Permit Application Review Report
Date: 8/20/2025

Project Name: Meadow Creek Church

Project PAN: P-25-017

Project Purpose: Construction of a new building and parking lot reconfiguration/reconstruction with utilities and associated stormwater treatment

Figure 2: Site Plan

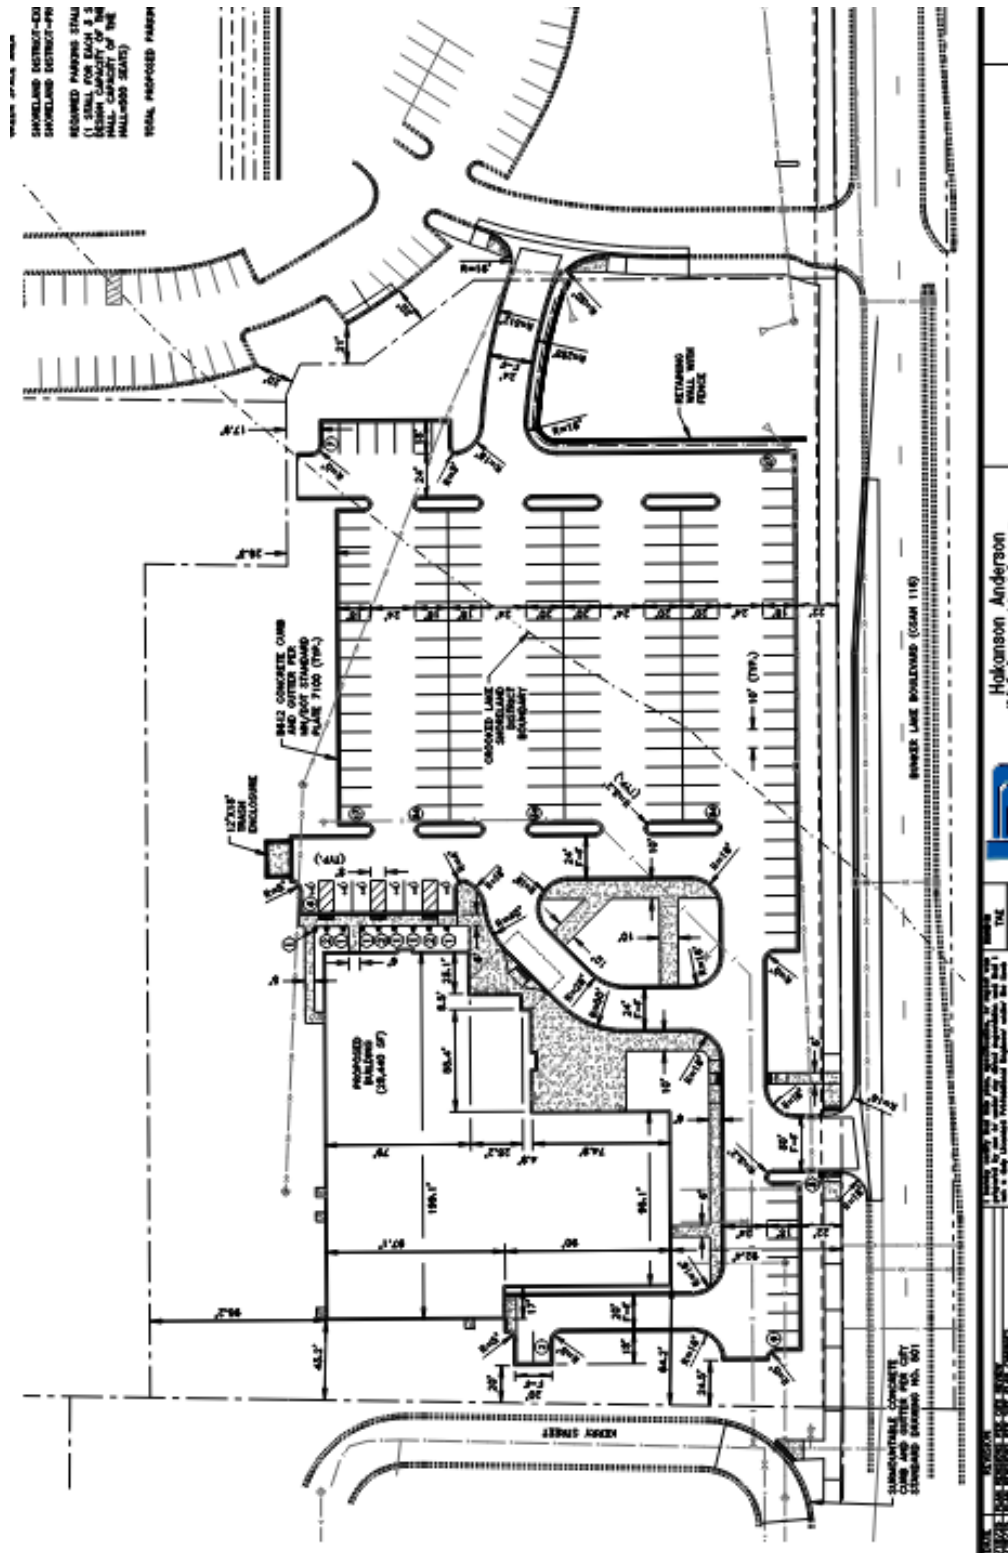
Description: The applicant is proposing the construction of a new building with associated parking lot reconstruction and reconfiguration with stormwater treatment features. The project will disturb 5.5 acres and create 2.9 acres of regulated impervious surface. The parcel drains toward County Ditch 54. The relevant water resource concerns are stormwater management and erosion and sediment control, which correspond to District Rules 3 and 4. See attached Figure 1: Project Location and Figure 2: Site Plan.

Figure 3: Soils and Erosion Control

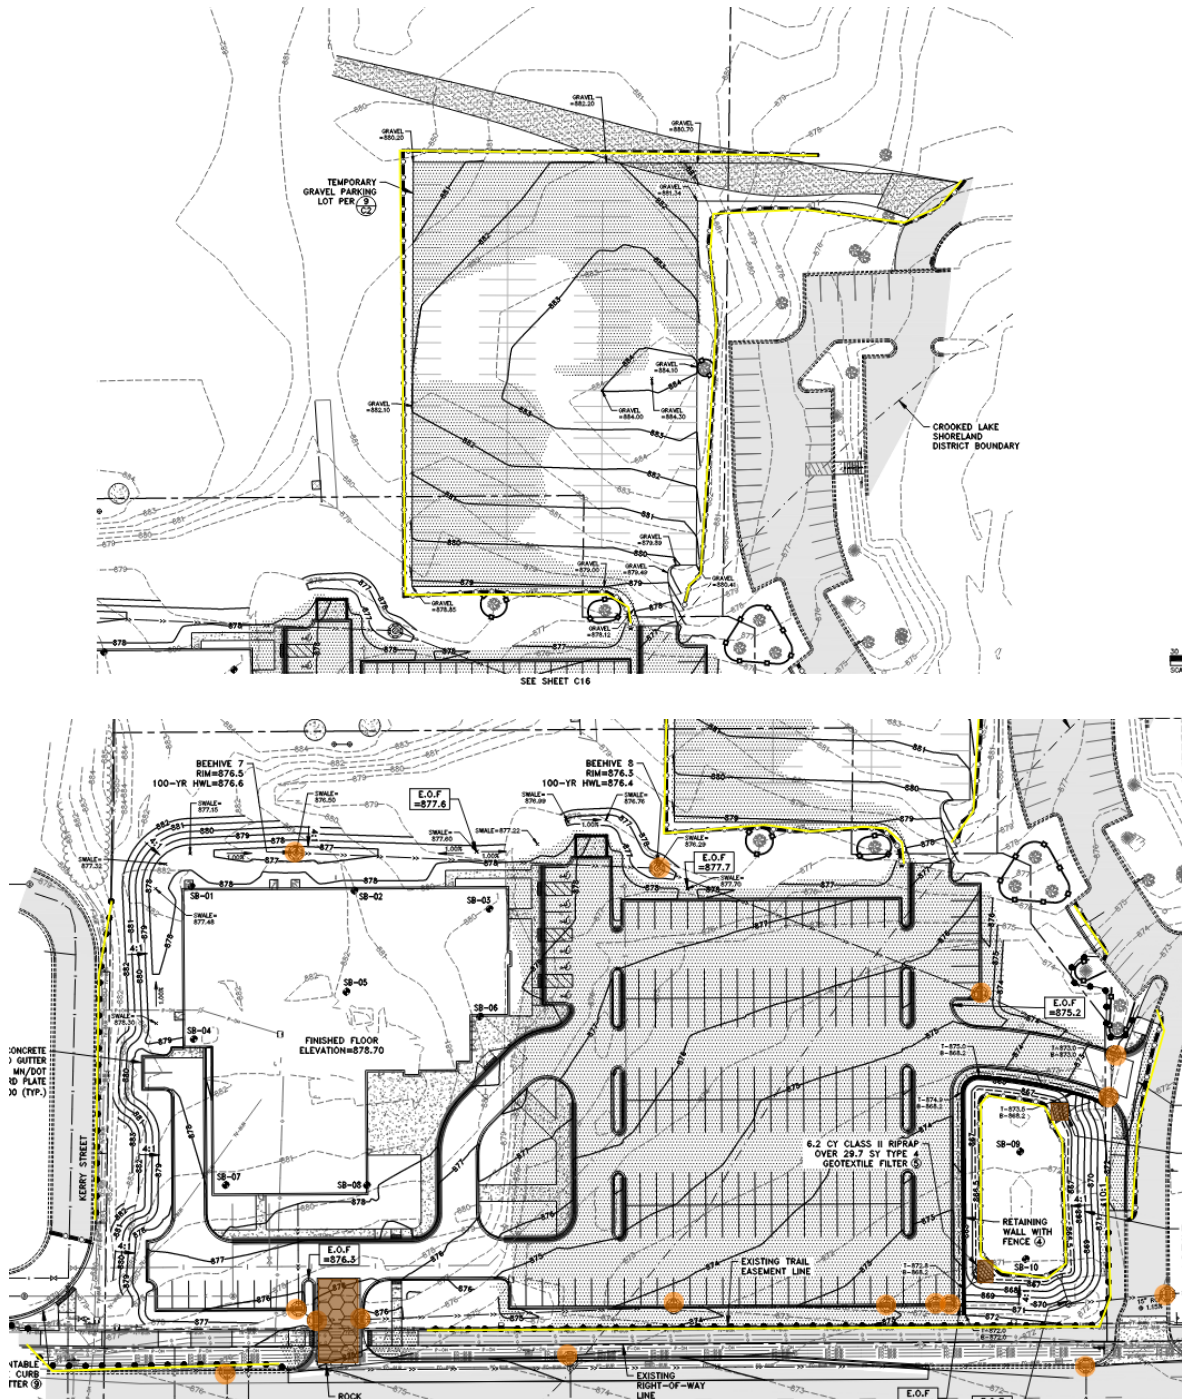
The proposed project drains to County Ditch 54. The soils affected by the project are Nymore which does not have a soil erodibility factor of 0.15 or greater. Disturbed areas are proposed to be stabilized within 7 days, as required. The proposed erosion and sediment control plan includes perimeter control, inlet protection, stabilized construction entrance, and street sweeping. The erosion control plan meets District Requirements. The site does require an NPDES permit and a copy was provided. See attached Figure 3: Soils and Erosion Control.
